Melton East PSP

Submission to Amendment C244melt

3L Alliance

31 MARCH 2025

Figure- Realigned Taylors Road/Mount Cottrell Road Intersection

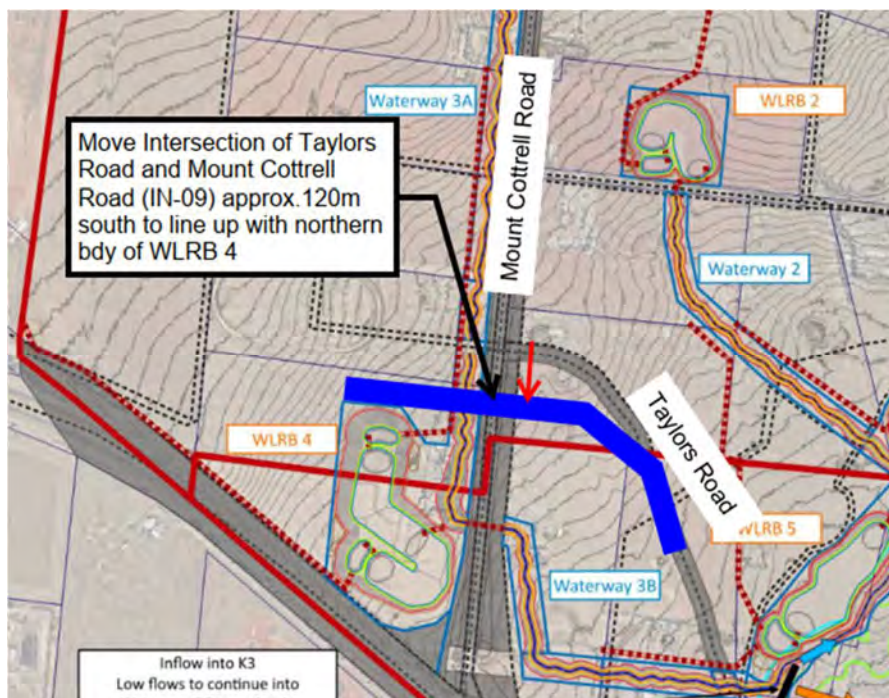
Realign Taylors Road and Mount Cottrell Road intersection per figure below:

Figure- Elongation of WLRB4

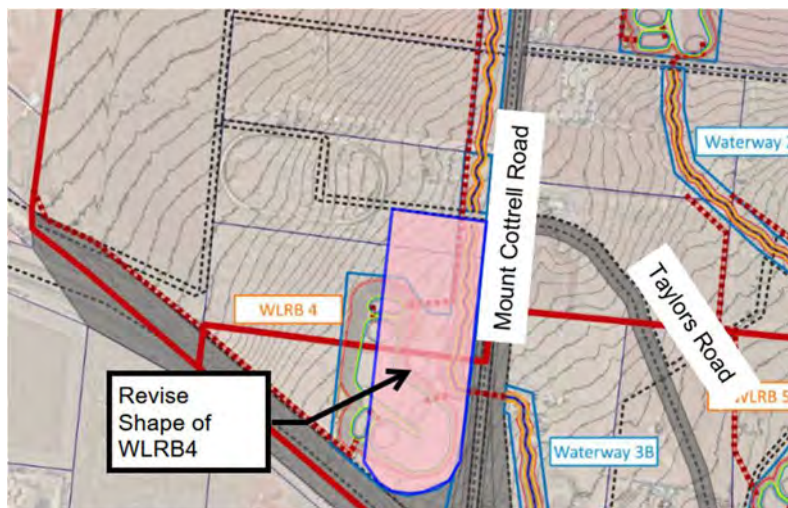
- ▶ Elongate shape of WLRB4 to better utilise space between Connector Road and Highway.
- ▶ This will provide for a more efficient urban design outcome.

Figure- GWW Sewer NSP 2024 (Extract) with Melton East Proposed Staging and Stage 1 Delivery Requirements

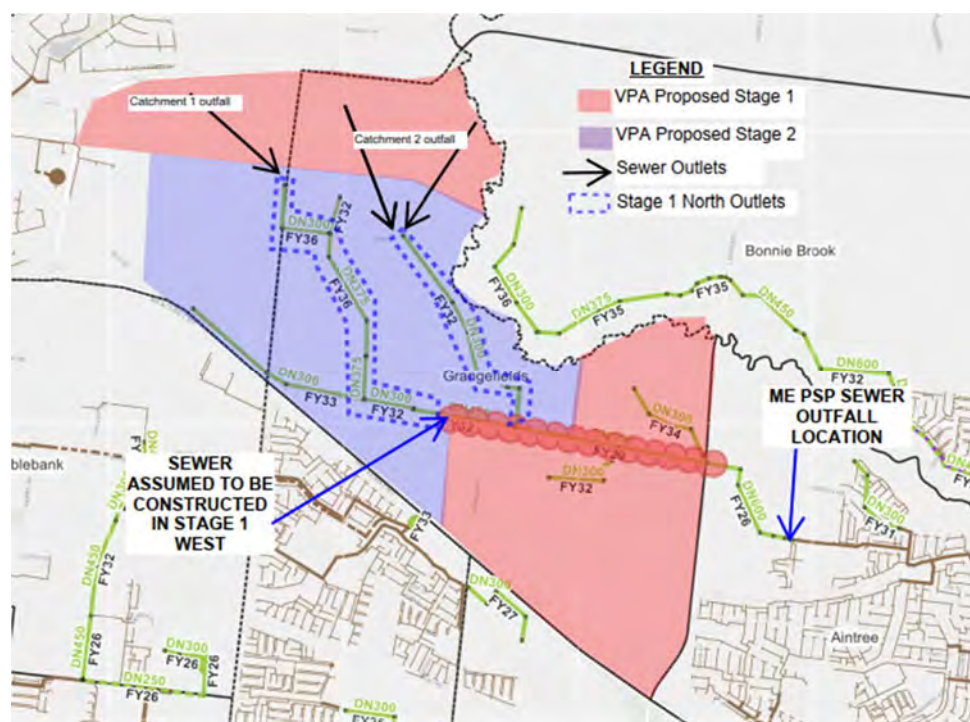
Bringing forward this sewer requires access agreements with approximately 11 landowners, all of whom are in the proposed Stage 2. These landowners may not be willing to consider development outcomes early in the PSP delivery while Stage 1 is being rolled out. There is significant risk in installing sewerage through future development areas, as the respective installation alignments restrict flexibility in urban design without costly relocation works. If any of the 11 landowners do not cooperate, Stage 1 North may be unable to be delivered at all.
